RELATING TO RESOURCES AND DEVELOPMENT COMMITTEE; APPROVING A  
TEMPORARY CONSTRUCTION EASEMENT FOR THE TERM OF ONE YEAR TO THE  
NAVAJO NATION WATER RESOURCES DEPARTMENT FOR THE PURPOSE OF  
REPLACING THE BITSUI STEEL SIPHON THAT BENEFITS NENAHNEZAD AND  
SAN JUAN CHAPTER FARMERS

# FINAL BITSUI SIPHON CONCEPTUAL DESIGN REPORT

30% Design Review

# Trench Design

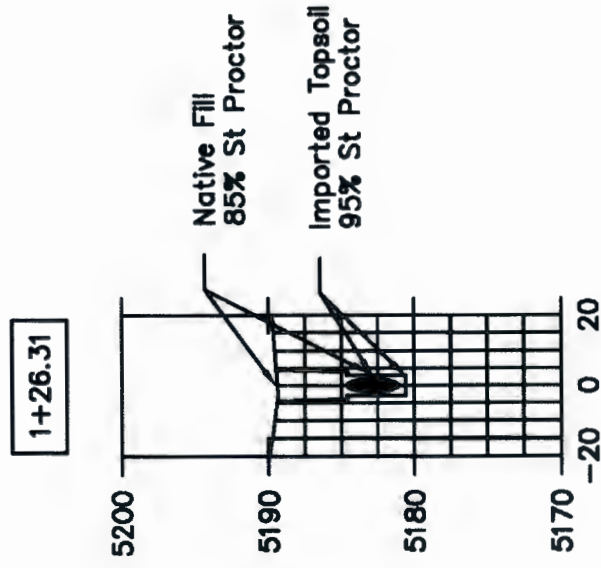
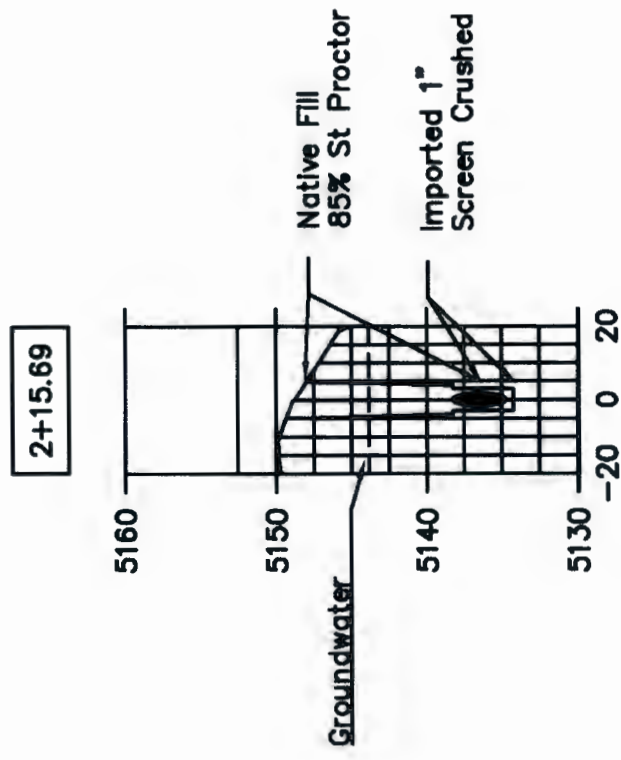
3. Reviewed Drawing P101. Edits required include:
  - a) Need of location drawing, general layout drawings, and demolition drawing
  - b) Place trench detail on detail drawings for both saturated and non-saturated conditions
